May 30, 2023

Re: Landmark Square Building 3 ZB Application #223-12

As discussed, we offer the following responses and updated materials pursuant to our review of the application materials with you on 4/1423 and subsequent discussions with LUB and TTP staff on 5/23/23.

5 ATLANTIC STATION STAMFORD, CT

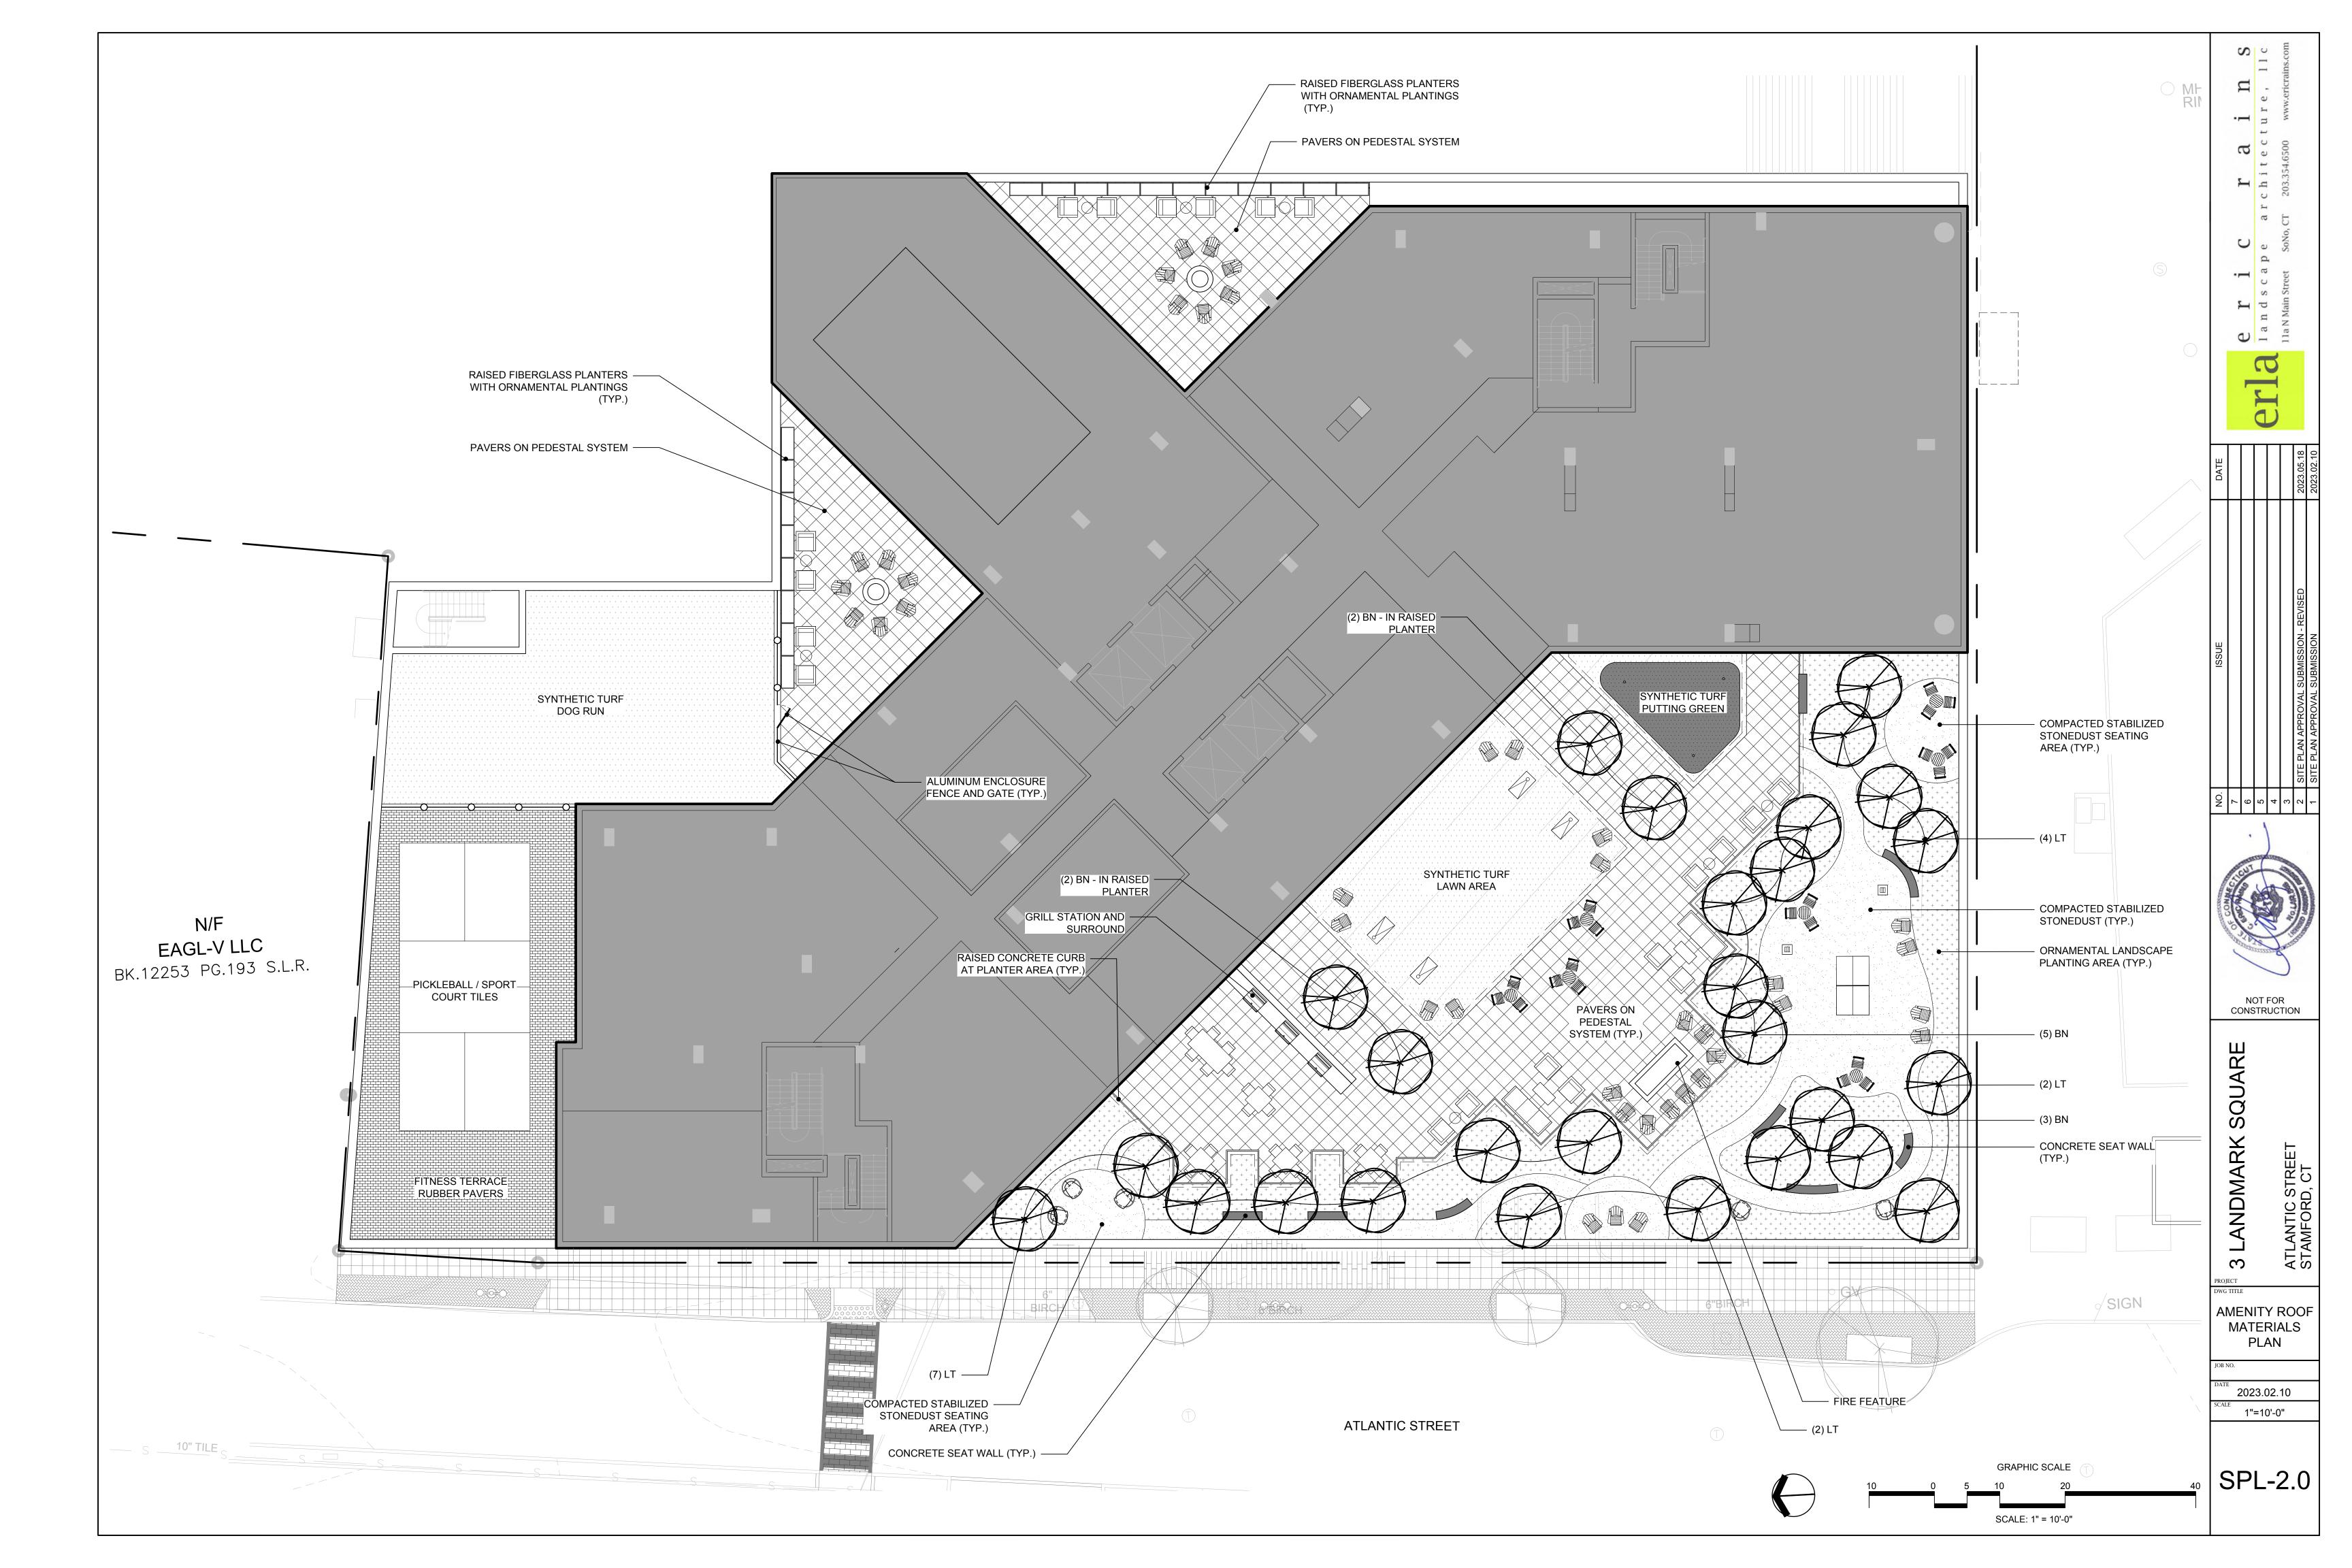
- i. the façade grid lines (which have been confirmed to have a 3" to 4" depth) and bay windows with a 2' depth.
 - ii. Metal panel garage screening which will be aluminum and not susceptible to rust. This type of screen is used on Atlantic Station and is available in a variety of finishes including flat, specular and gloss.

GROUND FLOOR PLAN (GR/G1)

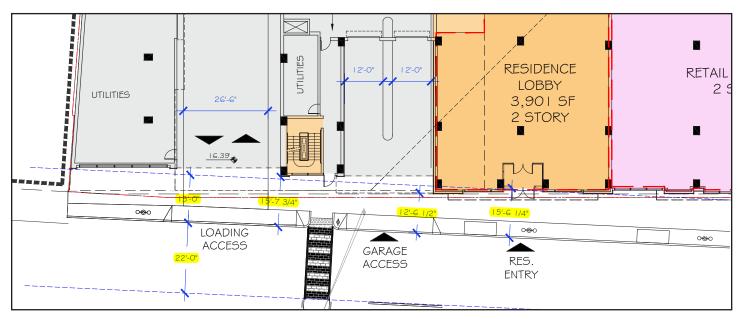
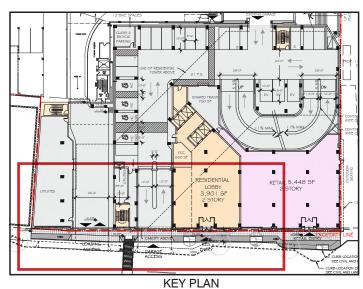
- d. Paving treatment to accent the building entrance is shown. The applicant is happy to implement this subject to approval from Engineering and TTP.
- 5. Pursuant to discussions with LUB and TTP staff, the proposed building and sidewalk alignment, in the event that the City's proposed Atlantic Street redesign is not implement and existing roadway design is maintained, has been updated. The building has been cut back at the ground level along the garage and utility rooms, and the sidewalk has been pushed out where feasible to maintain the existing 22' travel width between the curb and median along the frontage. This provides the requested 15' sidewalk dimension along the entire frontage except for a pinch-point at the north end of the lobby where it is minimally 12.5'.

We understand this to be an acceptable "fall-back" position in the event that Atlantic Street is not redesigned and is a significant improvement from existing conditions where the clear path is as narrow as 4' in some instances.
